# ALTOS ONE

PARKING STALL WIDTH  
WAIVER REQUEST

# Request: Reduce 82 parking stalls to 8'-6" wide from 9'-0" wide

**ALTOS ONE**  
4856 & 4846 EL CAMINO REAL  
LOS ALTOS, CALIFORNIA 94022

## BUILDING EXIT ANALYSIS PLAN

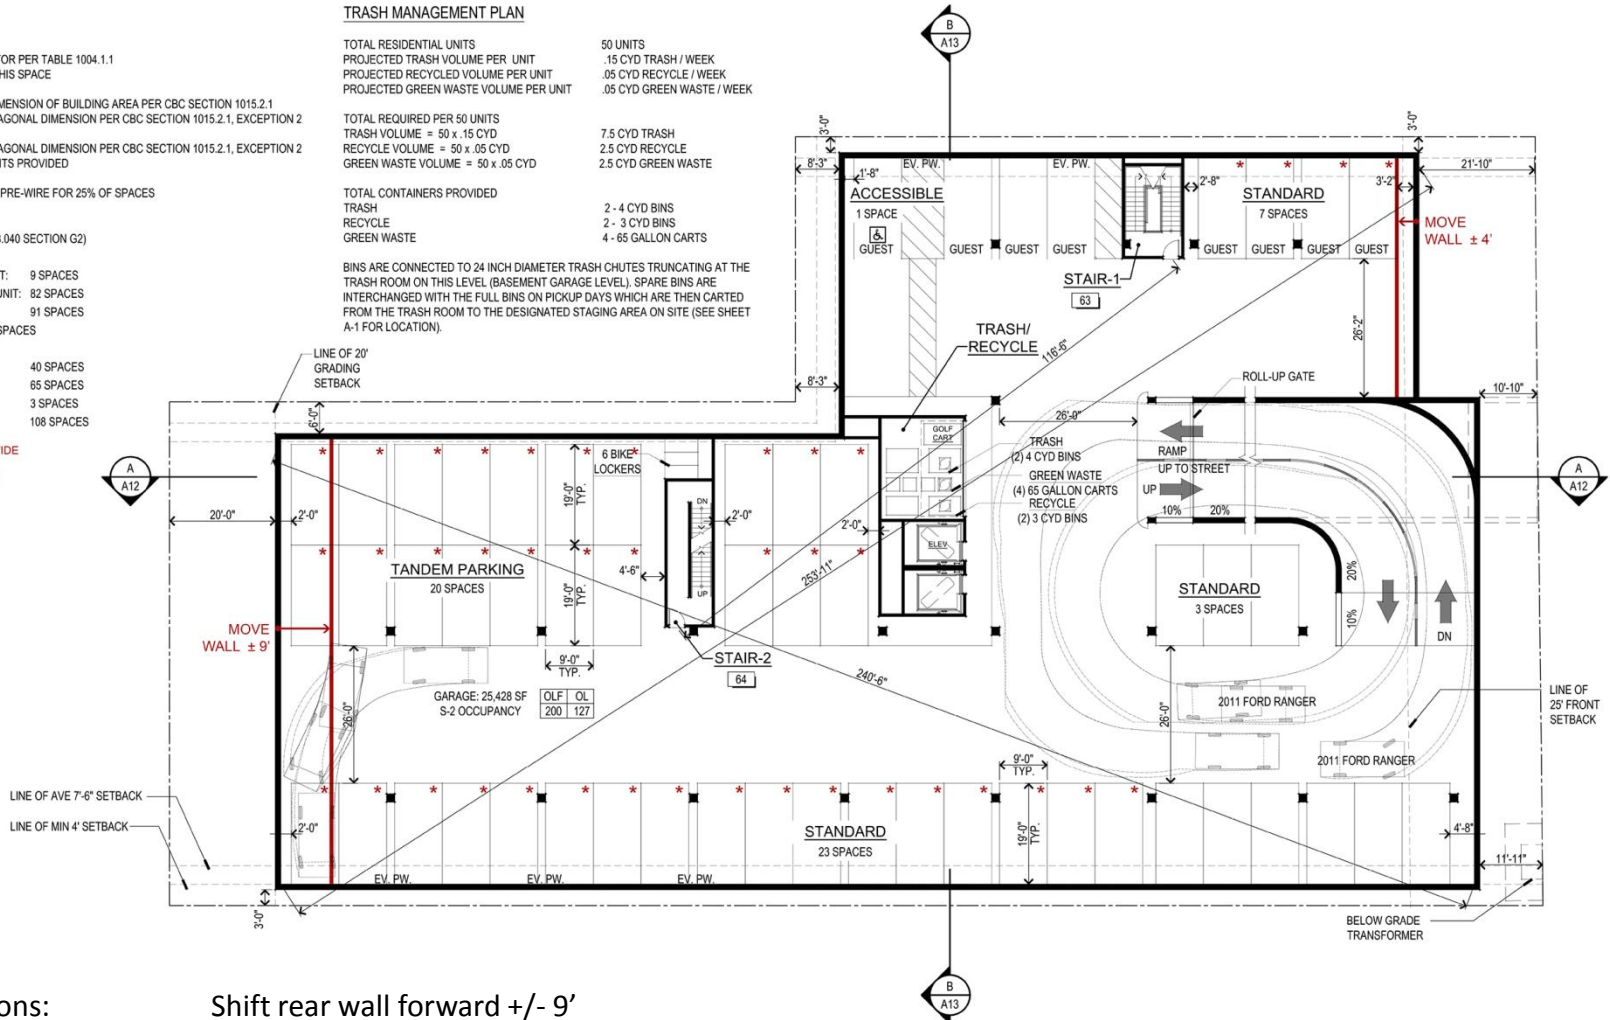
REDUCE ± 75% OF SPACES TO 8' X 18'

\* 82 SPACES @ 8' X 18'  
26 SPACES @ 9' X 18' (STANDARD)

Garage revisions:

Shift rear wall forward +/- 9'

Shift front wall back +/- 4'

Install 27 outlets for EV Charging Stations (in lieu of 13 pre-wires per approval)

Reduce grading and off-haul by +/- 650 cubic yards (60+ truck trips)

Increase soil zone around redwood trees

Increase landscape in front setback and rear yard (create more park-like user-friendly landscape)

## BUILDING EXIT ANALYSIS PLAN

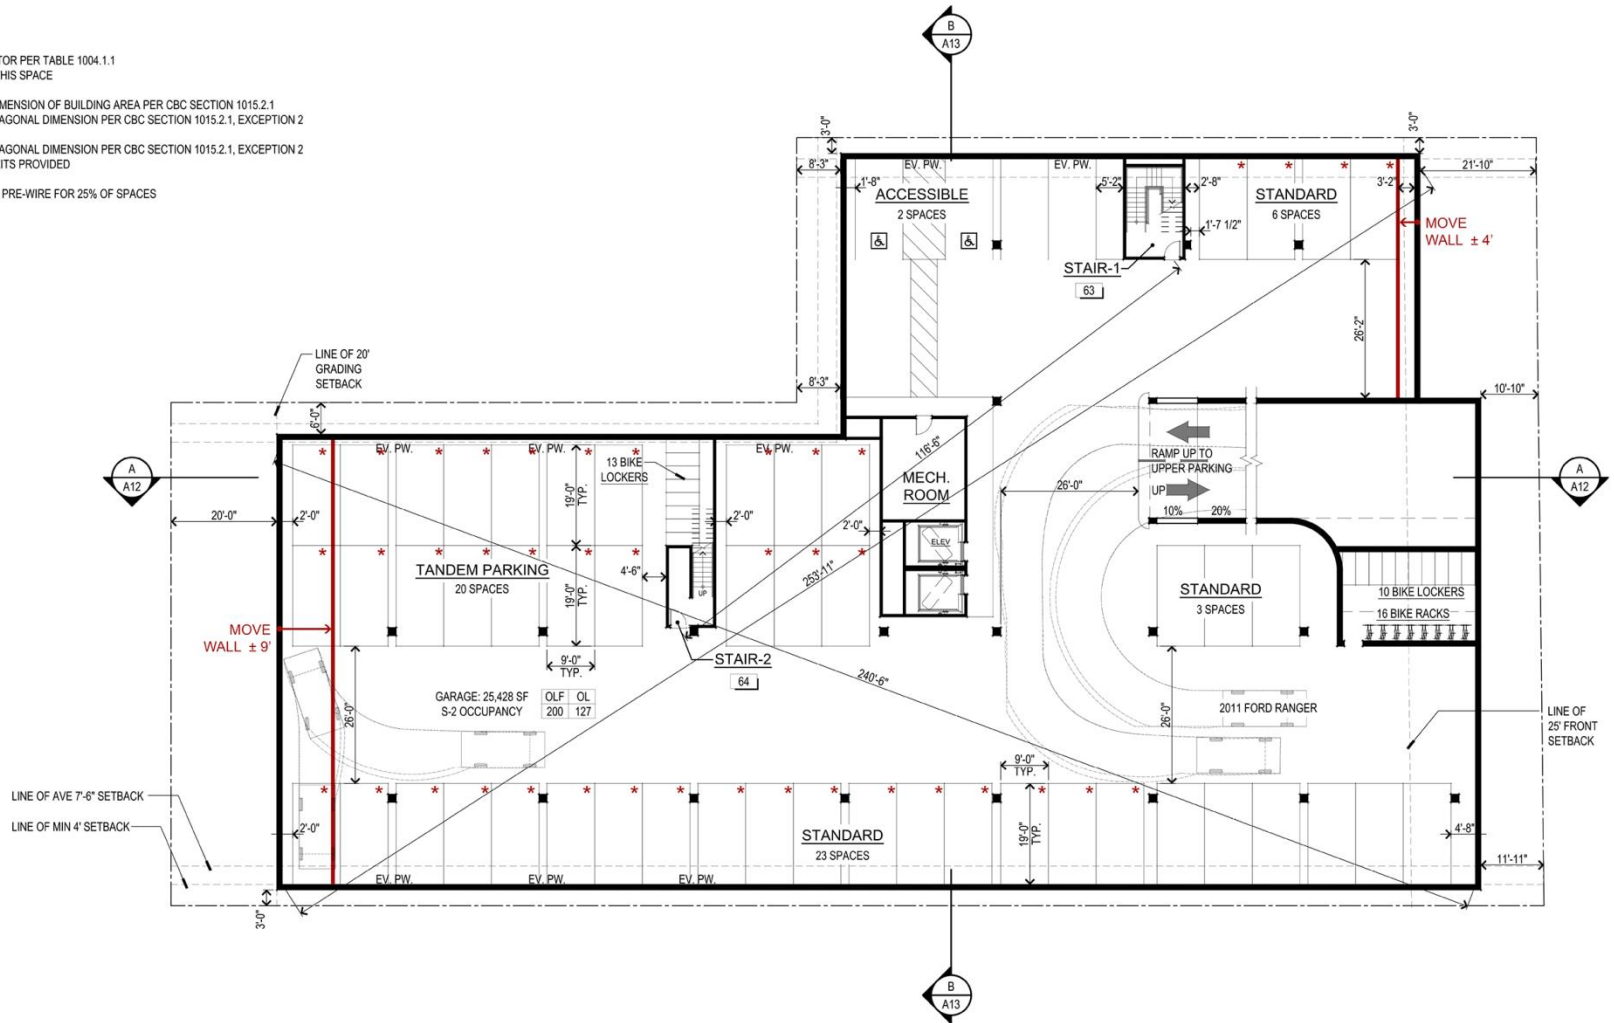
Project includes 108 parking stalls where 93 are required by code  
 26 standard width spaces remain including half of the guest parking  
 76% of total spaces (82 of 108)  
 72% of required spaces (67 of 93)

Landscape revisions:

- Increase front yard landscaping
- Increase soil zone around redwood trees
- Create more park-like user-friendly landscape
- Add child's play area
